Enclosure (1) - Navy's Response to DOH Comments on *Draft Groundwater Model Report*, dated September 24, 2024

Figure 3-1
USGS RHMW16 Colloidal Borescope Results
DOH RTCs to Sept 2024 Model Report
Red Hill Bulk Fuel Storage Facility
JBP HH, Oahu, HI

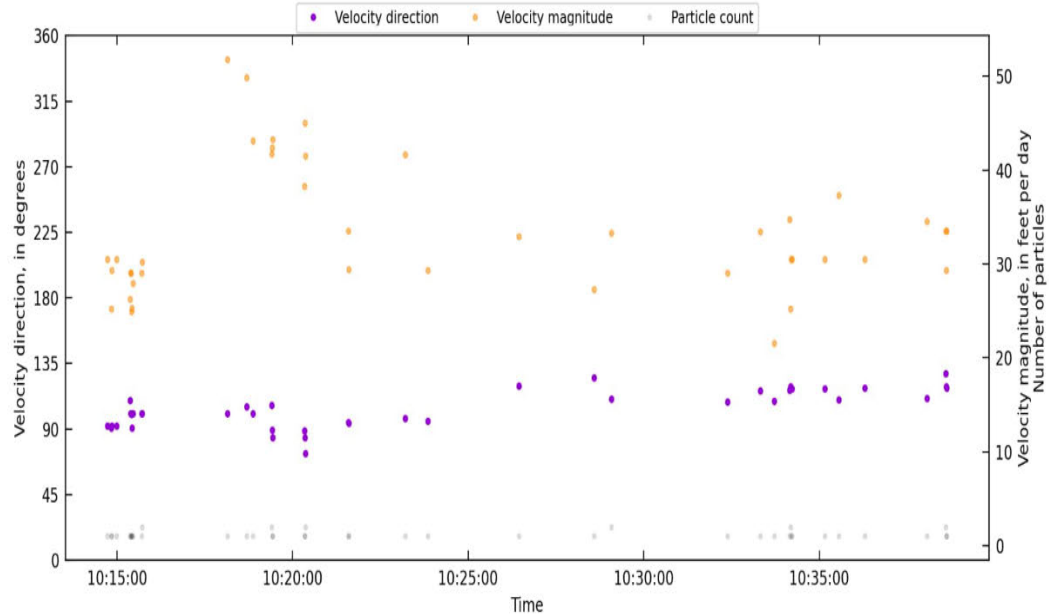
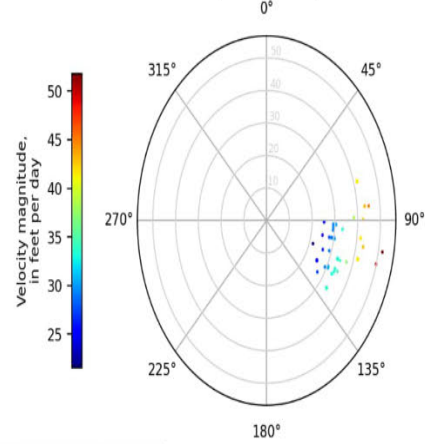
- Groundwater velocities also changed over time, even for flow measured at the same depth in a single well. At RHMW16, within 30 minutes, flow rates ranged between 15.8 to 56.2 ft/day. In RHP04B, groundwater velocities ranged between 13.3 and 33.2 ft/day over roughly 20 minutes. At RHMW04B, the average flow direction was 346 degrees on October 10, 2024, but 304 degrees the next day (October 11, 2024), a difference of 42 degrees over a 24-hour period at the same depth.

More relevant at this time than the preliminary UH colloidal borescope data for well NMW27 are the final USGS colloidal borescope data and analyses. Figures 3.1 through 3.5 (enclosed) duplicate figures published by USGS to their website' based on their analyses of borescope data from well RHMW16.⁴ Well RHMW16 is directly northwest of the Red Hill Tank Farm. In all these figures, not a single data point suggests flow to the northwest. Overall, based on the available preliminary results, it is not clear whether all the colloidal borescope tests run in different wells indicate a consistent flow direction.

Attachment 1 –
Cross-ridge Gradients

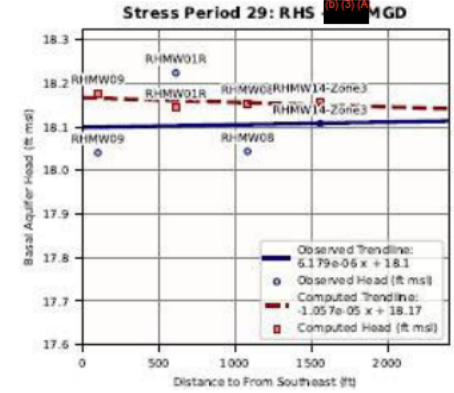
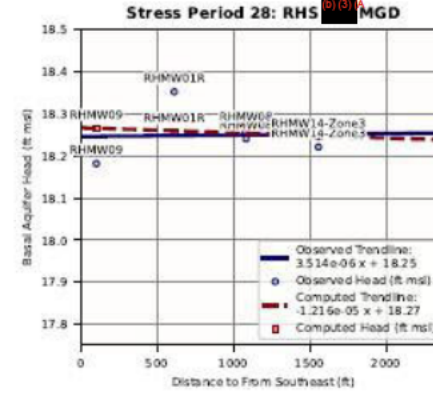
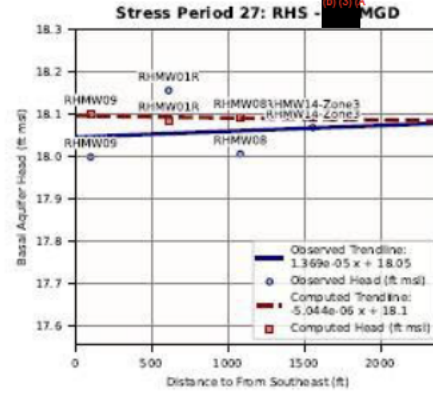
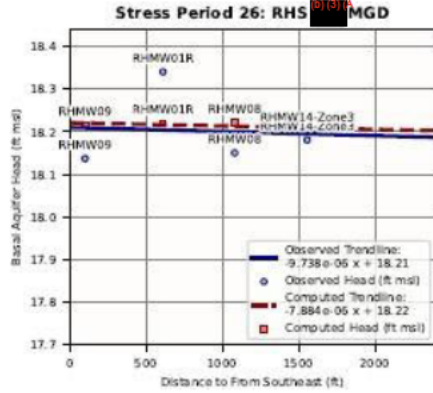
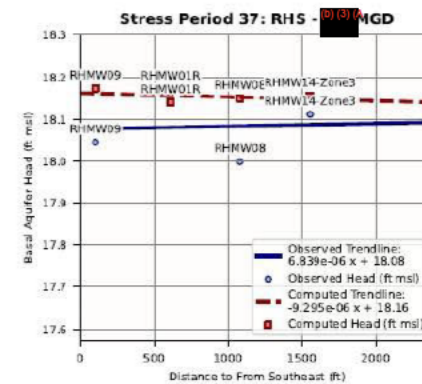
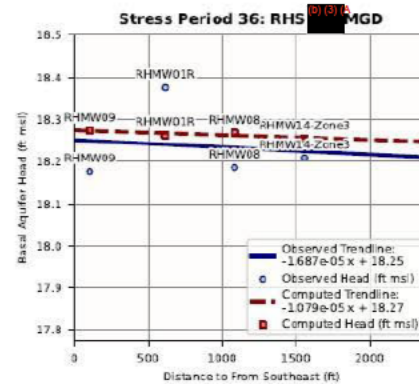
c. Consistent with the contaminant detections to the northwest of the USTs, the groundwater gradient is much steeper in that direction than down the axis of the Red Hill Ridge, as the model predicts. The model should objectively investigate the apparent cross ridge gradients.

Navy Response - As explained above and discussed in the SPMs conducted on April 27, 2022 and January 31, 2024, there is strong evidence that the detections of TPH-d and TPH-o north and northwest of the Tank Farm are not associated with migration of groundwater from the Tank Farm. Attachment 1 (enclosed) provides cross-ridge plots presented in the same format as the ridgeline gradients presented in the 2024 GWM Report. The three sections span these wells:

1. RHMW09, RHMW01R, RHMW08, RHMW14-Zone3
2. RHMW19, RHMW01R, RHMW16
3. RHMW03, RHMW20, RHMW12A

Reasonable matches to the cross-ridge gradients were achieved with the current groundwater flow model. On average, the simulated cross-ridge gradients are slightly greater than observed, which would be conservative with respect to northwest groundwater flow as well as hypothetical risk to Halawa Shaft. These plots will be included in future reports and the gradient targets will be integrated into the model calibration.
